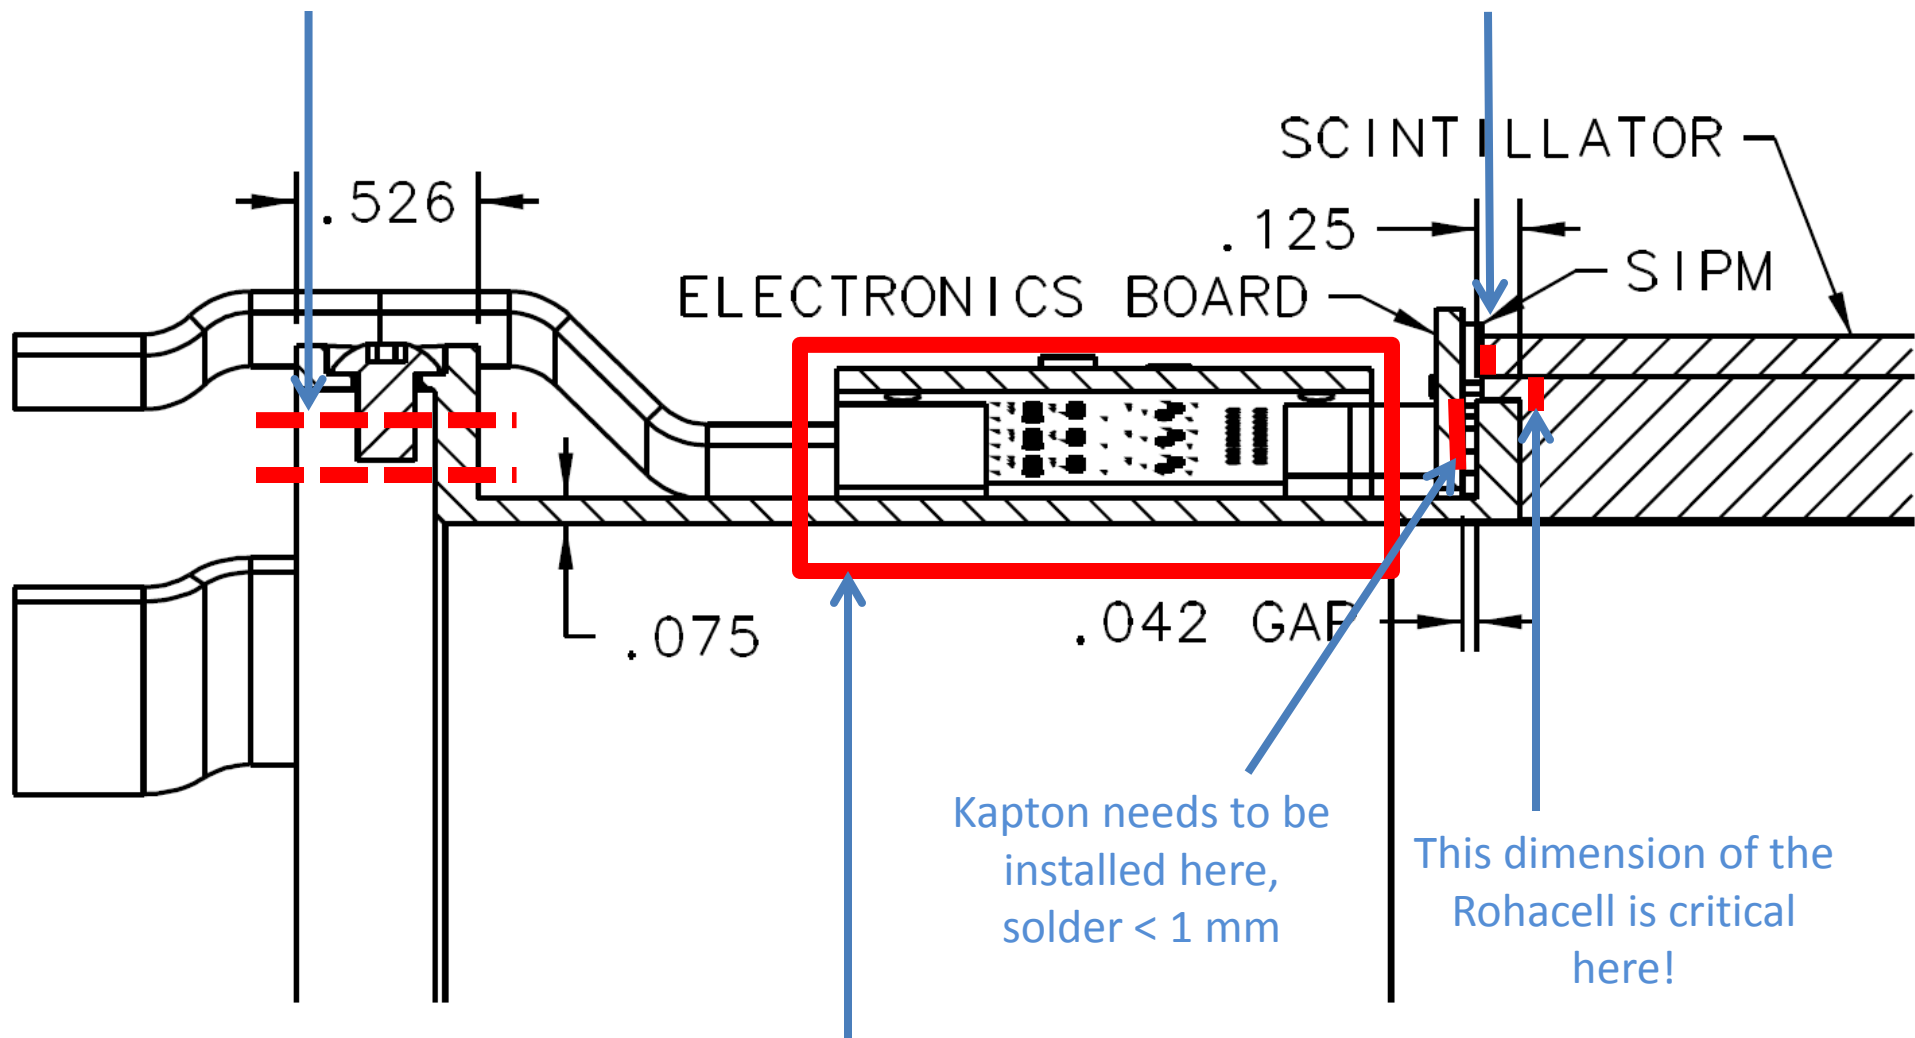
Need 4 Tapped Holes at 90 deg apart for plate attachment (assembly jig)

Coupling of Scintillator to SiPM

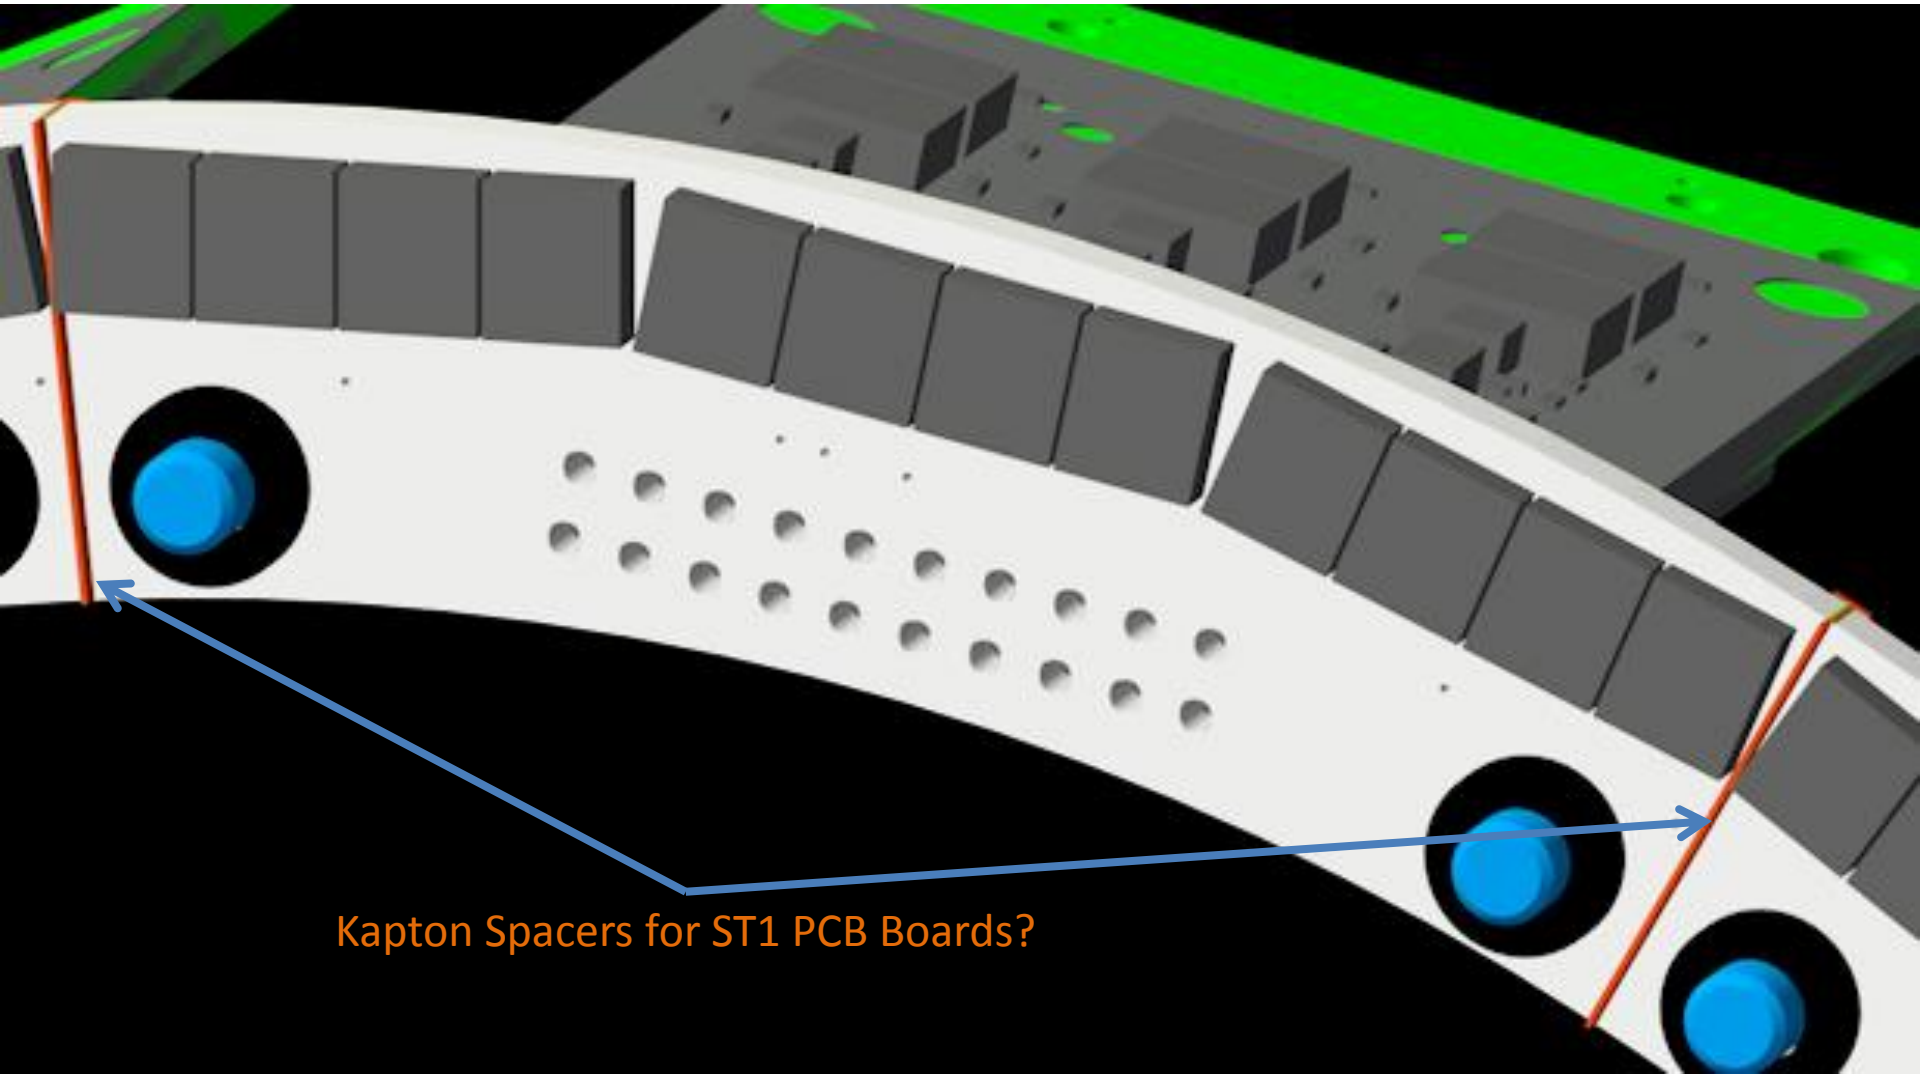
ST2 cannot come into contact with the support hub (Kapton?)

Kapton Spacers for ST1 PCB Boards?
